# SUSTAINABLE DESIGN REVIEW COMMITTEE

## MEETING AGENDA (REVISED)

SUBJECT: PREQUALIFIED SDP STATUS – Extreme Granite, located on south side of Maple Road, west of John R (1890 Maple Road), Section 35 – Zoned IB

# PARKING EXPANSION TO EXISTING EXTREME GRANITE

SHEET NO:
SP01

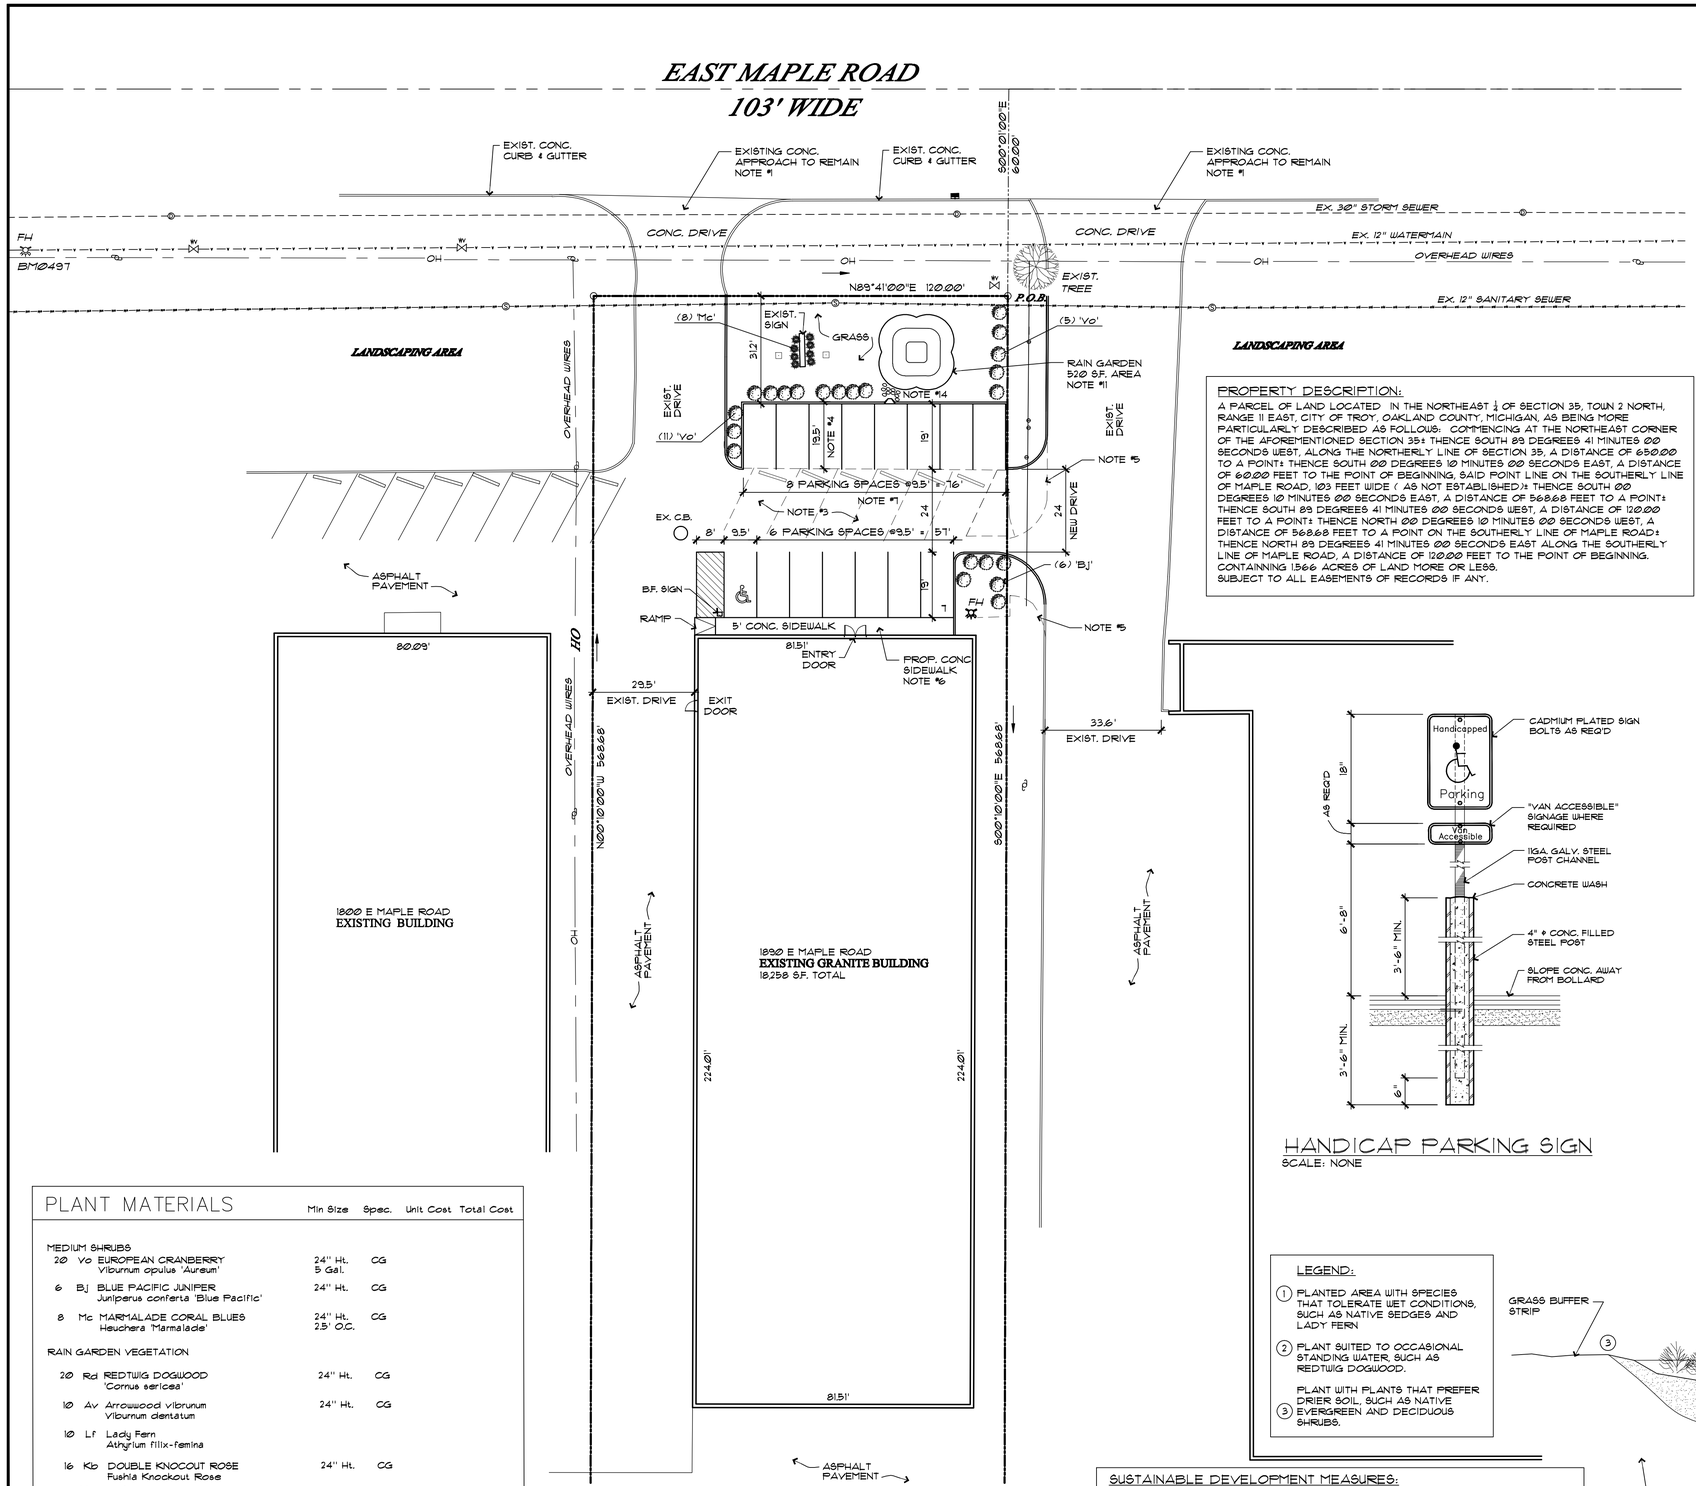
- Sanitary manhole and Water gatewell must be to grade and cement structure intact at completion of landscaping

- Landscaping at northeast corner of building must not obstruct or impede access to hydrant.

- New cross access with 1900 Maple is needed, this should be provided before any approval is issued.
- The rain garden details on the two sheets do not agree with each other, one has 6 inches of water the other shows 2 feet; neither shows any edge drain or overflow.
- SDP committee can decide if this minimal rain garden meets the criteria for front parking.

1. The proposed work encroaches onto the property to the east (1900).
2. The sustainable design measures here are minimal, I guess the SDP committee will need to decide if the proposal warrants the trade for the front parking area.

1. What are the SDP measures? Singular Rain Garden out front, lighting and water efficient landscaping? Is that enough?
2. Eight (8) foot sidewalk required along property frontage in Maple ROW.
3. Maple is an RCOC road and any work in the ROW requires an RCOC permit.
4. The last parking space in the NE corner of the new parking lot is directly adjacent to the property line and would require a driver to back out into the drive approach which is not preferred and not recommended due to the potential for conflicts with entering traffic from Maple to the new drive on the east side.
